ADDENDUM A
SOLICITATION #3450004900 / 20-FM-0042
01/31/2020

ODOT DIVISION V
BECKHAM COUNTY MAINTENANCE YARD
(SAYRE, OK)

This addendum contains corrections to the project specifications and plans.

Project: Oklahoma Department of Transportation – Beckham County Maintenance Facility
Location: Sayre, Oklahoma
Issued Date: 30 January 2020

SHEET
MA5.0

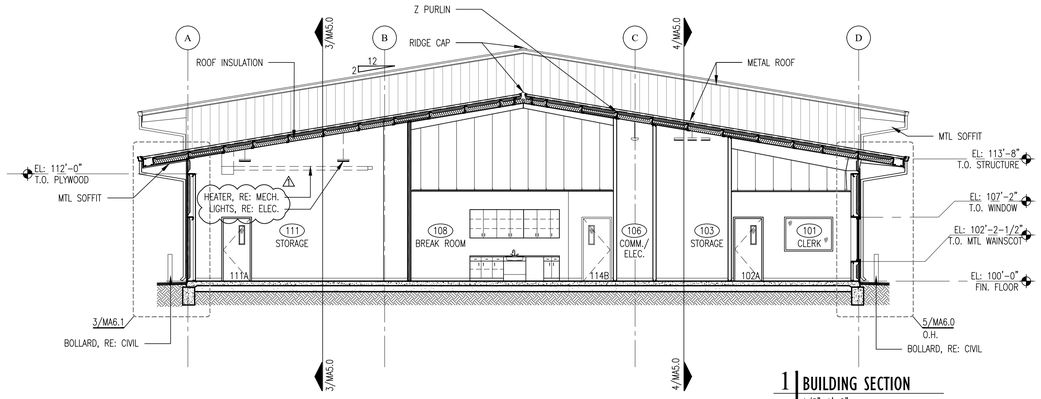
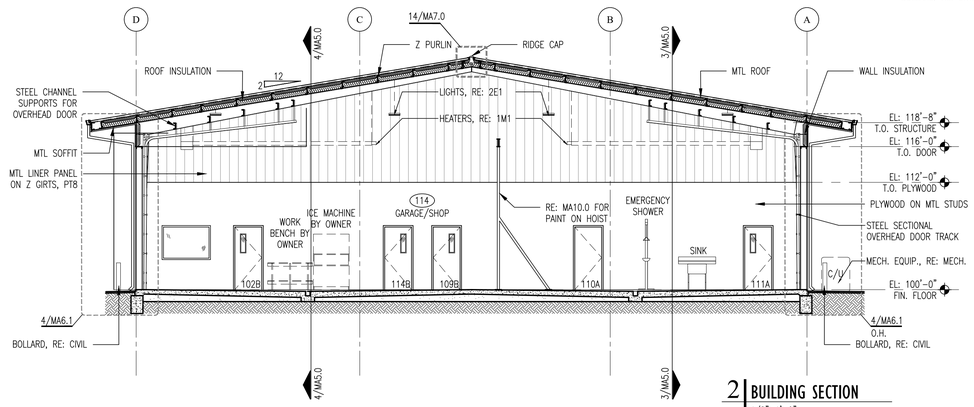
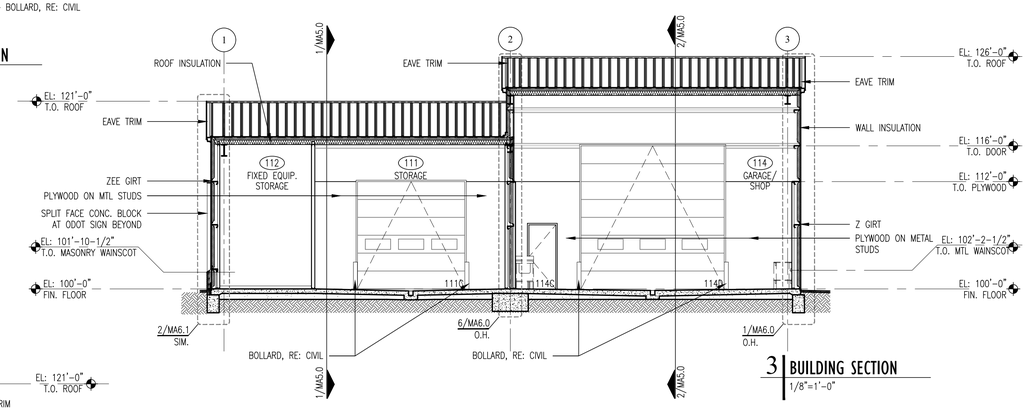
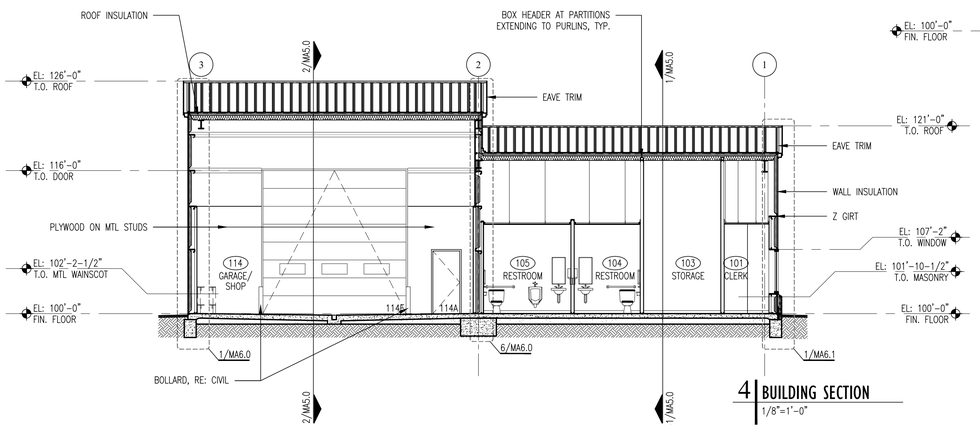
E. MA5.0 – Clarified mechanical and electrical references.
F. MA7.0 – Updated details 4, 10, and 15 to show a hemmed edge for the counterflashing rather than a drip edge.

MA12.0

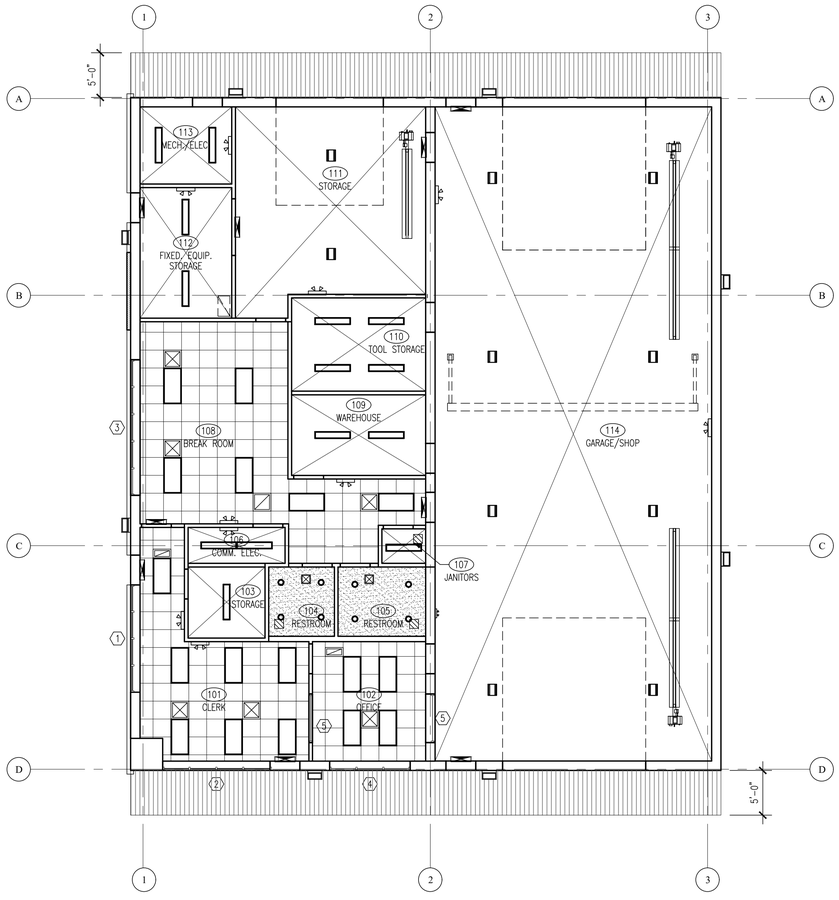
J. MA11.2 – Updated details 5 and 6 to include a note indicating end dams and that the weather barrier needs to be wrapped into the opening.
K. MA12.0 – Removed legend note indicating which fixtures have emergency battery backups. Added notes referencing electrical and mechanical in the legend.

SHEET
ME0.2

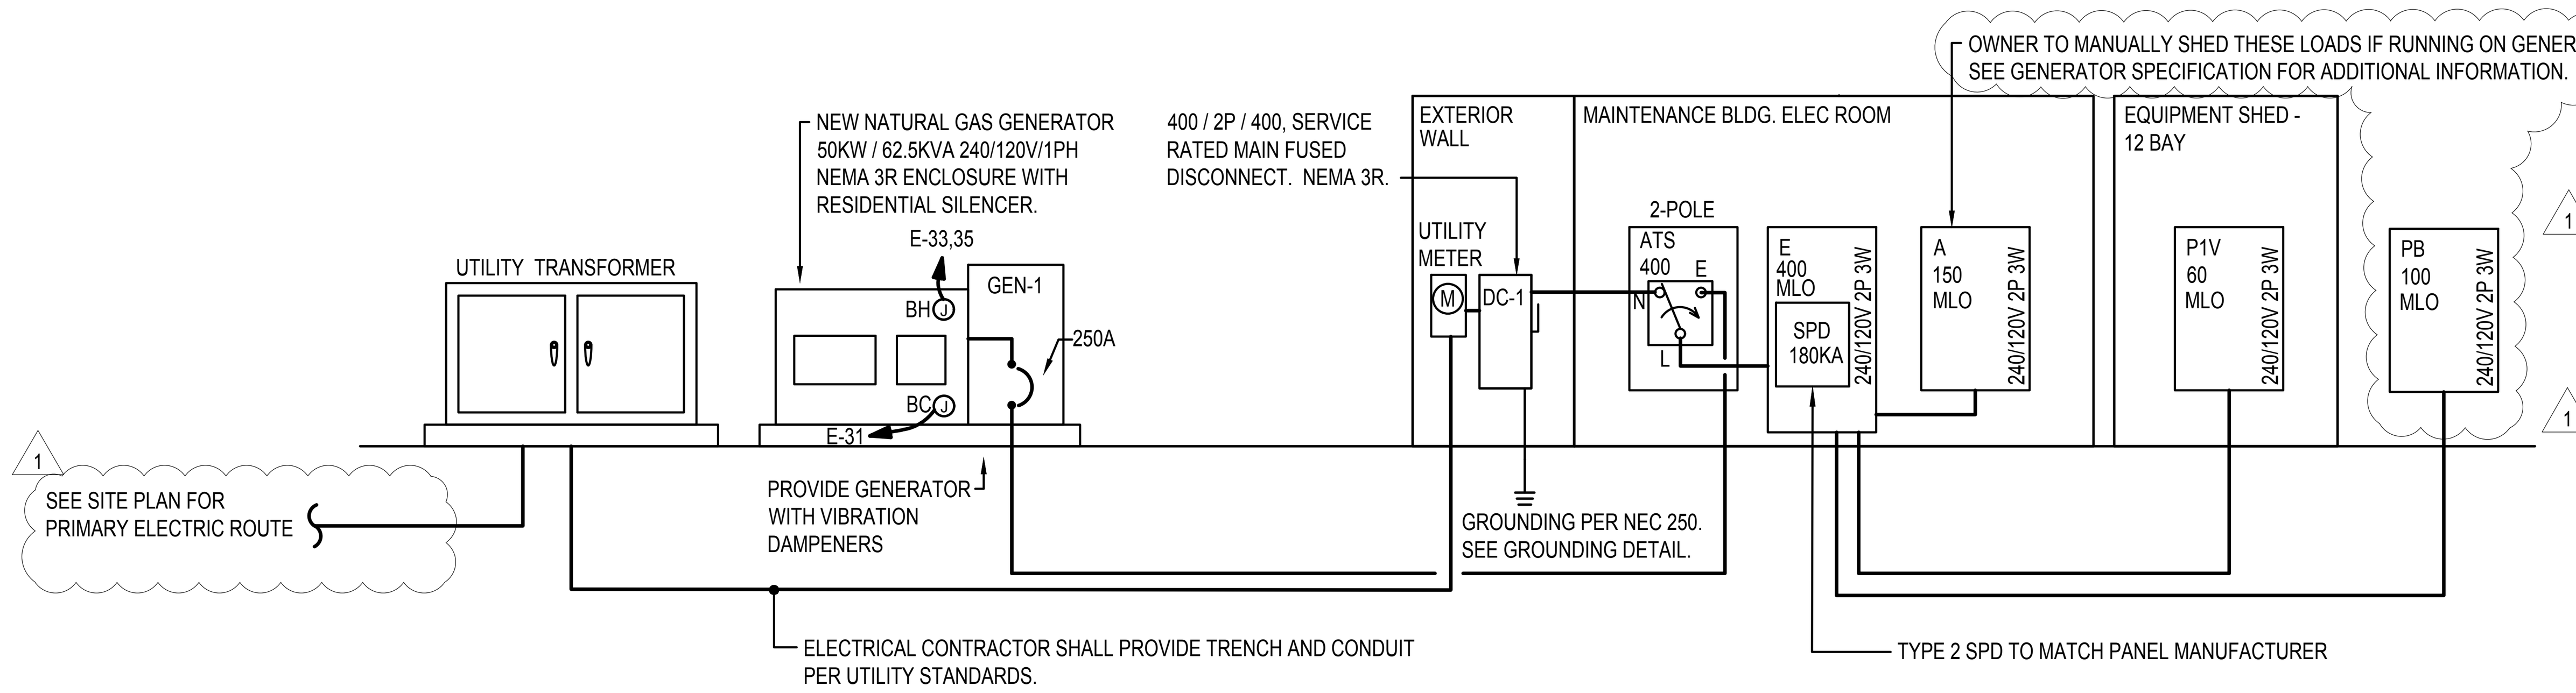
SHEET ME0.2	Replace sheet with attached; added panel PB for brine tank pad; clarified electric utility responsibility; changed breakers for fuel pump
SHEET ME0.3	Replace sheet with attached; clarified mounting of fixtures BA & BB; no pre-approval required (during bidding) on equal light fixture packages

ME1.1

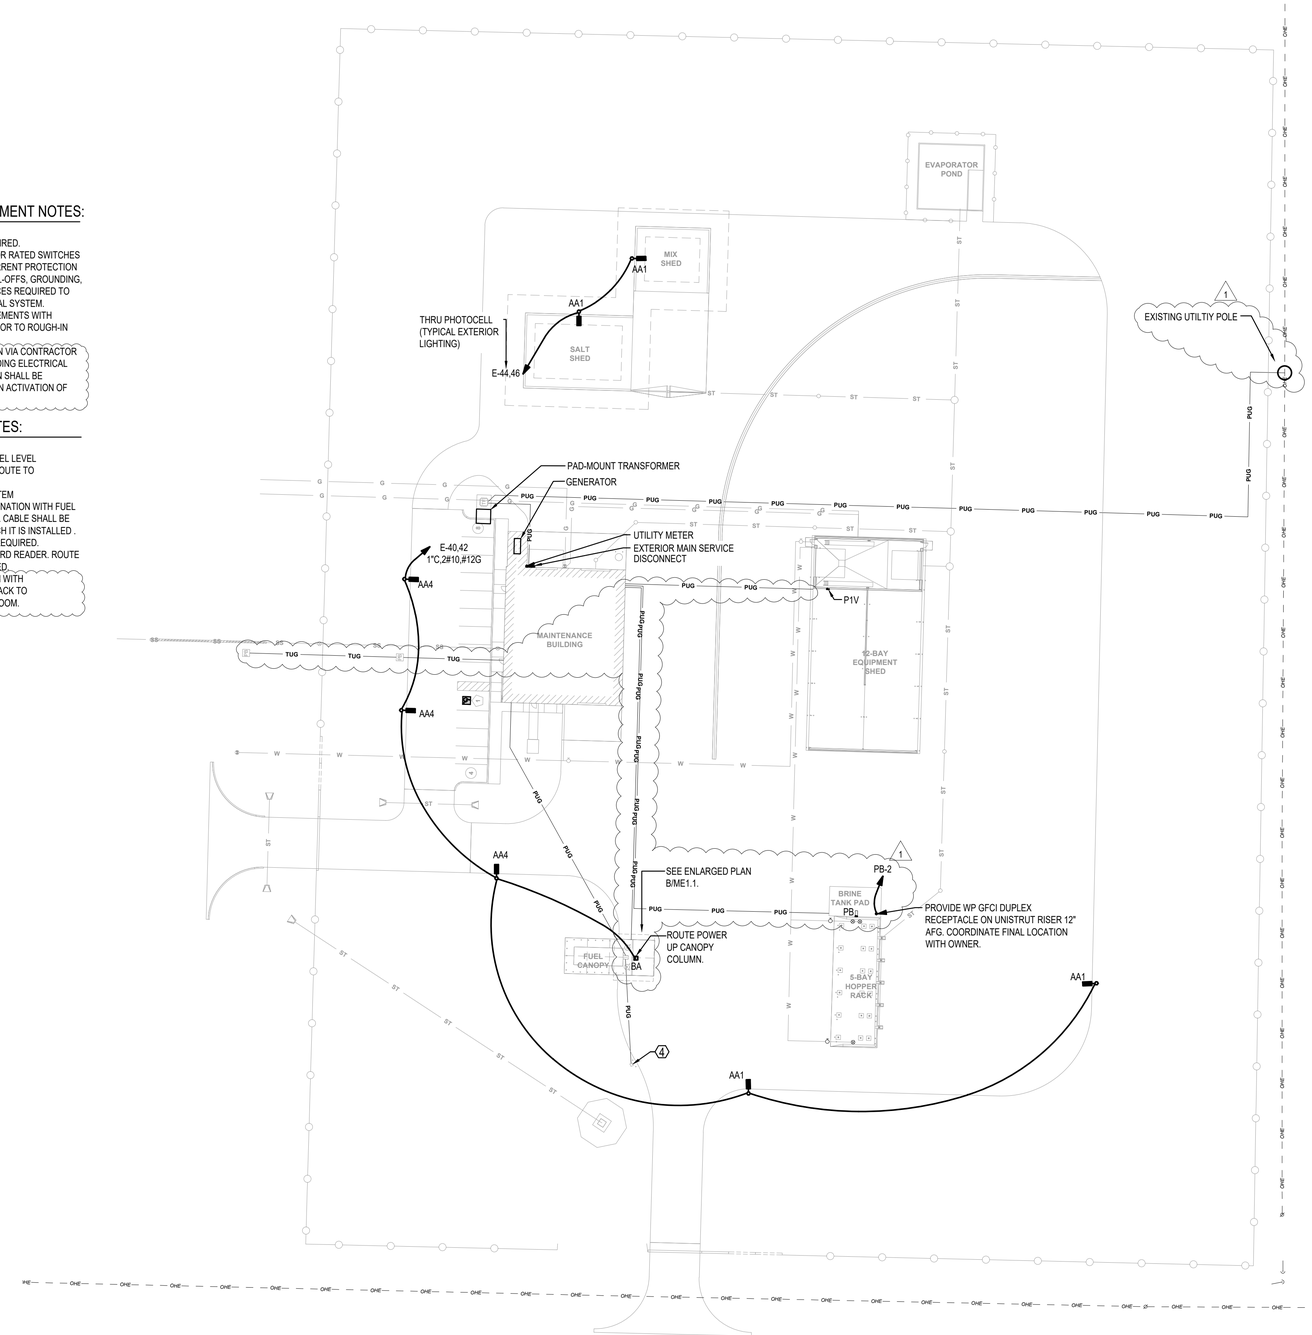
SHEET ME1.1	Replace sheet with attached; added panel PB for brine tank pad; clarified shunt/control for fuel pump power; changed fuel pump power to 208V

SHEET
ME2.1

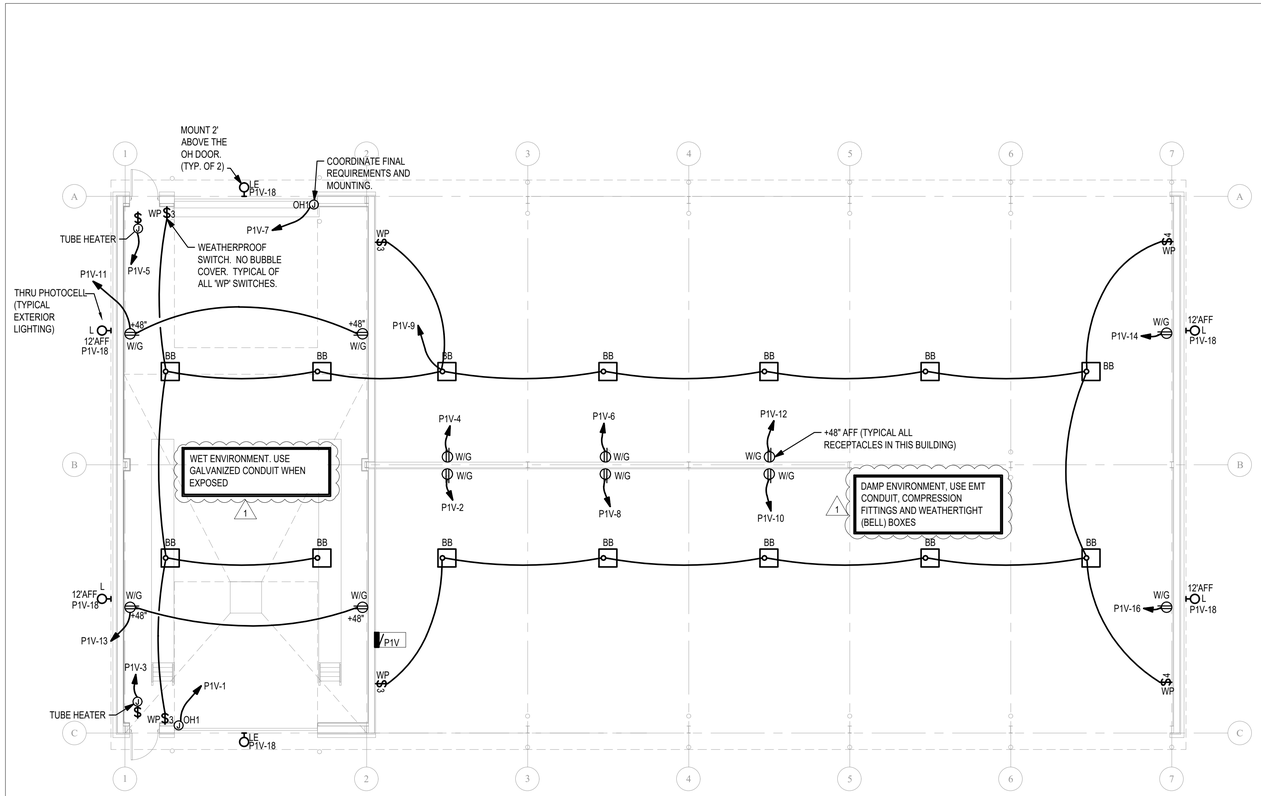
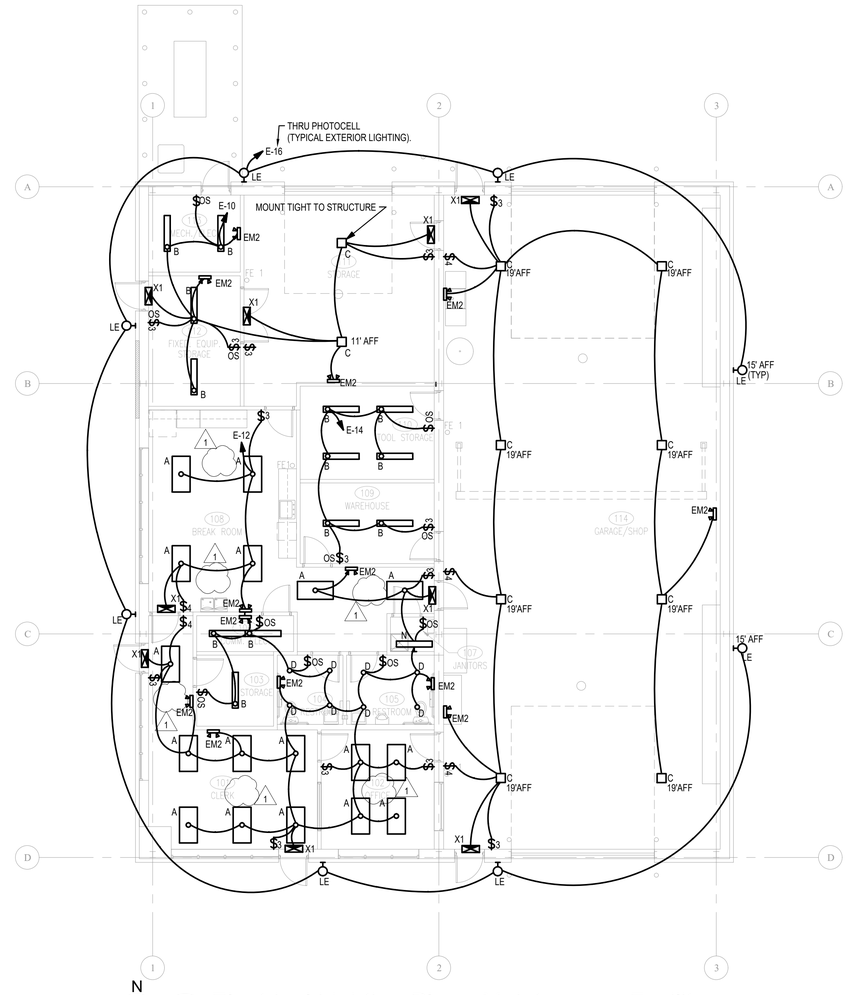
SHEET ME2.1	Replace sheet with attached; clarified environment rating & conduit type in equipment shed; removed ceiling-mounted occupancy sensors
SHEET ME3.1	Replace sheet with attached; clarified shunt/control for fuel pump power; reduced communications conduits to 2in

SHEET
MP1.1

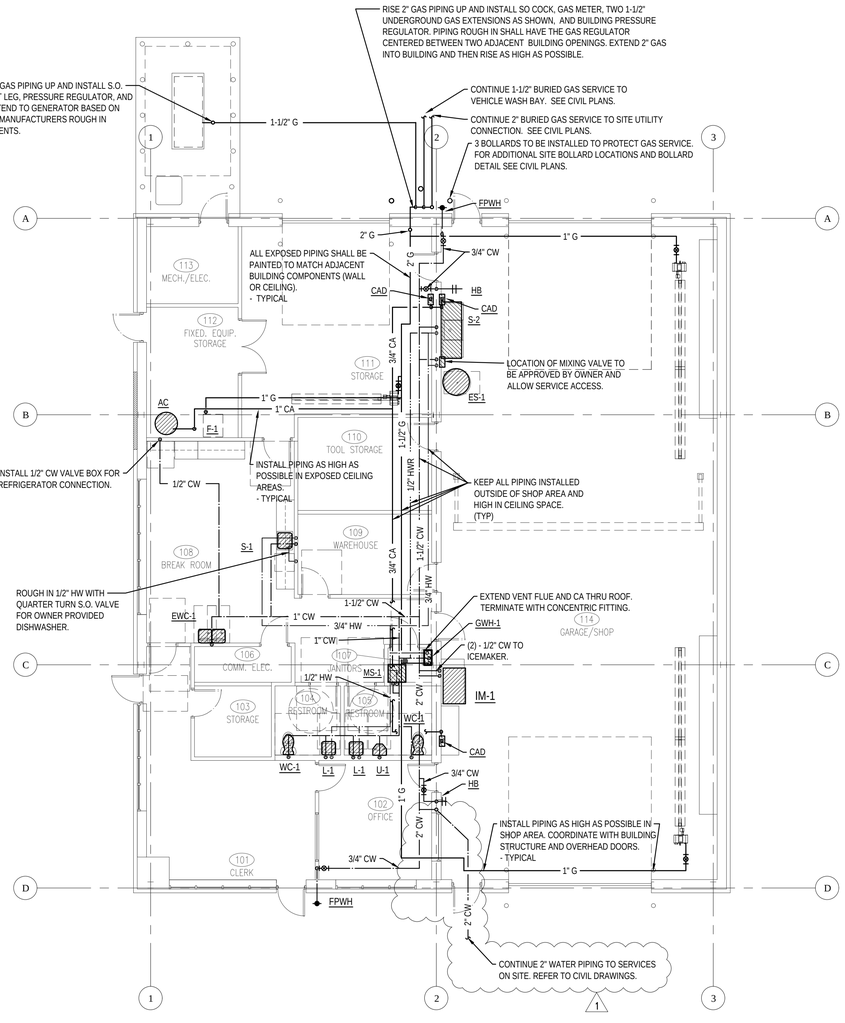
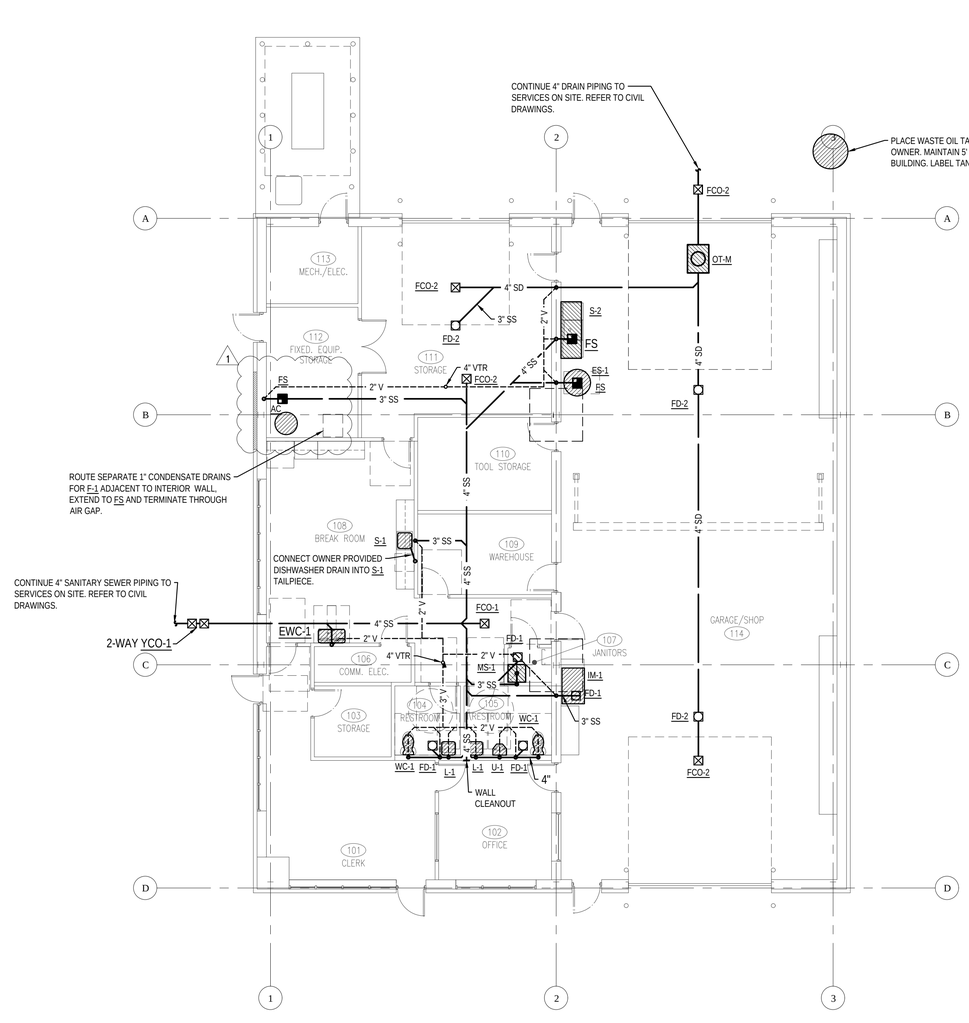
SHEET MP1.1	Replace sheet with attached; shifted floor sink near furnace & domestic water entry to avoid building foundations
SHEET VS1.1	Replace sheet with attached; refer to sheet CS1.1 for catwalk details

SHEET
VA2.0

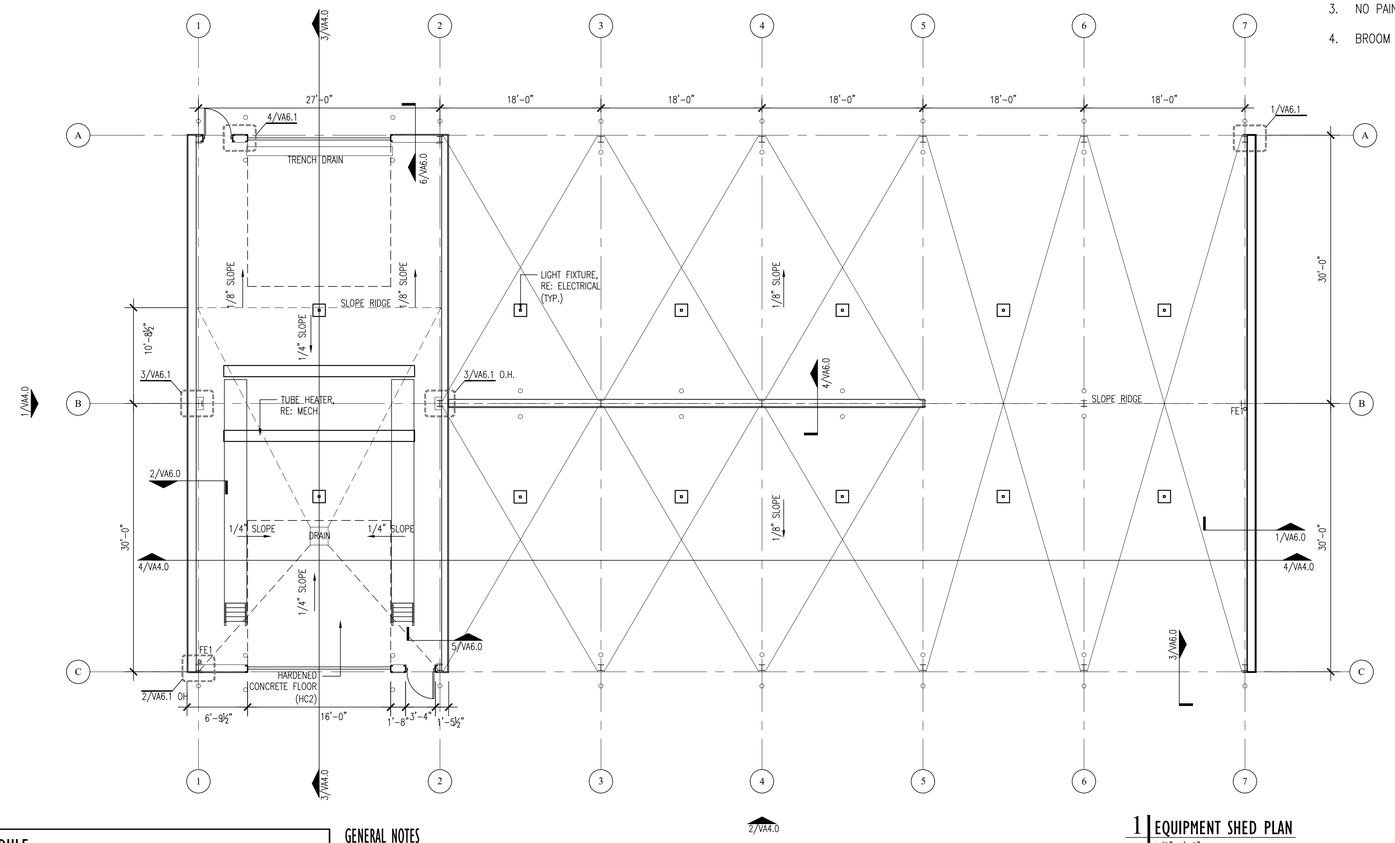
L. VA2.0 – Added PT9 to the Material Schedule and note 9 to the Material Schedule Notes.
M. VA6.1 – Added notes to details 8 and 9 indicating the inside closure set in sealant and that the bottom of the metal panel should remain 2" above grade.
